UNITED STATES
NUCLEAR REGULATORY COMMISSION
OFFICE OF NUCLEAR REACTOR REGULATION
WASHINGTON, D.C. 20555-0001

**NRC INFORMATION NOTICE 97-12: POTENTIAL ARMATURE BINDING IN GENERAL
ELECTRIC TYPE HGA RELAYS**

RELAY SERVICE ADVICE LETTER

Subject: HGA Armature Binding
Issued by: Customer Service
Prepared by: Peter A. Kotos

FIG. 1. (SIDE VIEW)

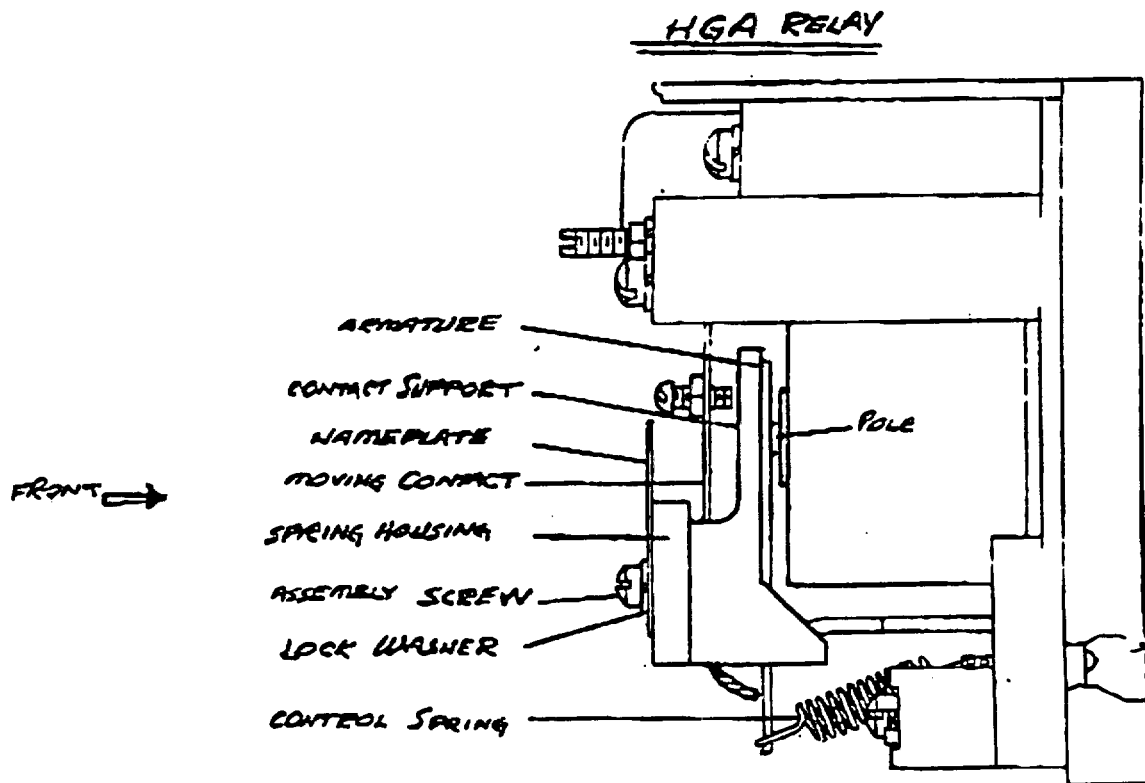
However, a dimensional analysis of the most critical parts indicated that the molded contact support was slightly out of tolerance. Specifically, the assembly hole of the contact support was slightly off center.

It is conceivable that this offset combined with the manufacturing tolerances of the armature and magnet frame, possible foreign matter in the hinge area and maybe excessive side pressure applied to the contact support when assembled could cause friction between the contact support and magnetic frame resulting in armature binding.

1. De-energize the relay, coil and contacts.
2. Close the armature fully by hand, (push armature against the pole, see Fig. 1), and gradually release. For correct operation, the armature should move to the fully open position with no binding and with correct contact action. The normally open contacts should open and the normally closed contacts should close. If binding is detected, we recommend the following:

The contact support should be replaced as follows: (Refer to Fig. 1)

1. Disengage the control spring from the armature end. (Note the groove location of the spring hook on the armature).
2. Remove the assembly screw with its lockwasher.

3. Remove the nameplate and spring housing assembly.
4. Remove the moving contacts from the contact support and note their location for correct reassembly.

5. Remove the contact support.
6. Install the new contact support. Make sure the armature is seated properly in the contact support.
7. Locate the moving contacts in the contact support.

8. Install the nameplate and spring housing assembly.
9. Tighten the assembly screw and lockwasher (16 in-lbs. approx.). Hold contact support and spring housing assembly together while tightening assembly screw.

10. Engage the control spring on the same groove on the armature of the relay.
11. Operate the armature of the relay by hand to make sure that there is no binding.

12. Electrically check, and adjust if needed, the pickup of the relay in accordance with instructions given in the Instruction Book of the particular relay model number.
